18/0983/OUT | Outline planning permission for a retail park (Class A1) along with complementary cafe/restaurants (Class A3) including means of access (all other matters reserved). | B And Q Avocet Road Sowton Industrial Estate Exeter Devon EX2 7JF

20th July 2018

Exeter Cycling Campaign **object** to the proposed development for the following reasons:

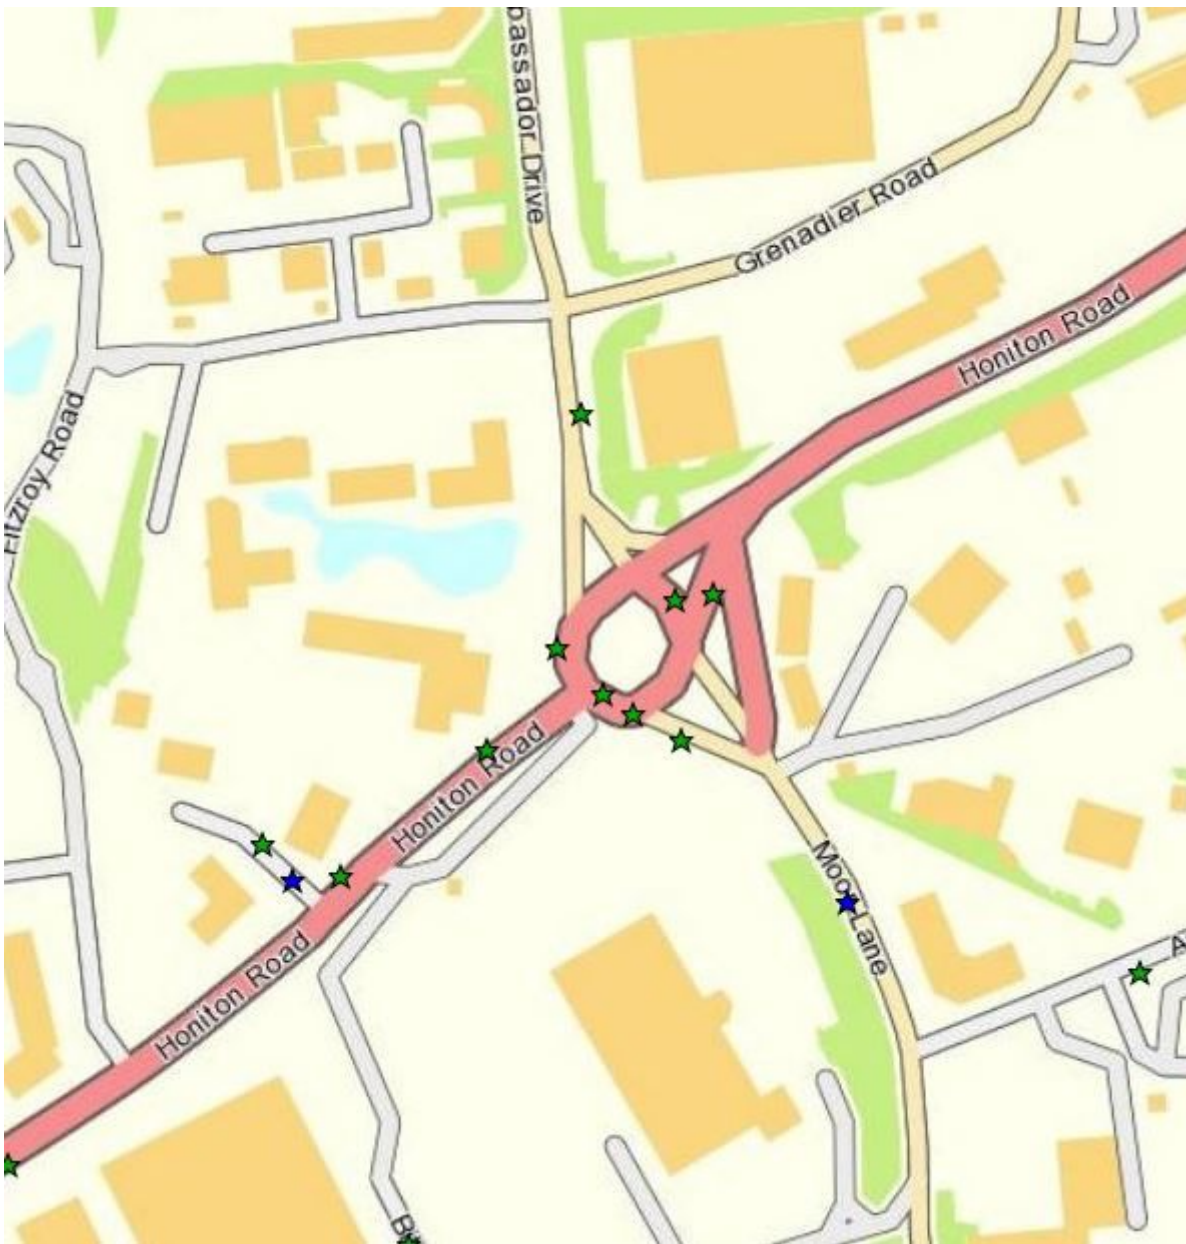
The Devon Collision Map, providing data up to December 2016, shows multiple collisions on and in the vicinity of Honiton Road/Moor Lane roundabout (Figure 1). This therefore make the roundabout a collision cluster spot and demonstrates that it is not safe. By definition, the roundabout and approaches will be particularly unsafe for vulnerable road users and unattractive to cycle on the road. The lack of quality, connected, segregated cycle routes in the area means that less confident cyclists or parents cycling with

children are not likely to cycle to the proposed development. This will further increase car usage, while putting vulnerable road users on Honiton Road, Moor Lane and the roundabout at greater risk.
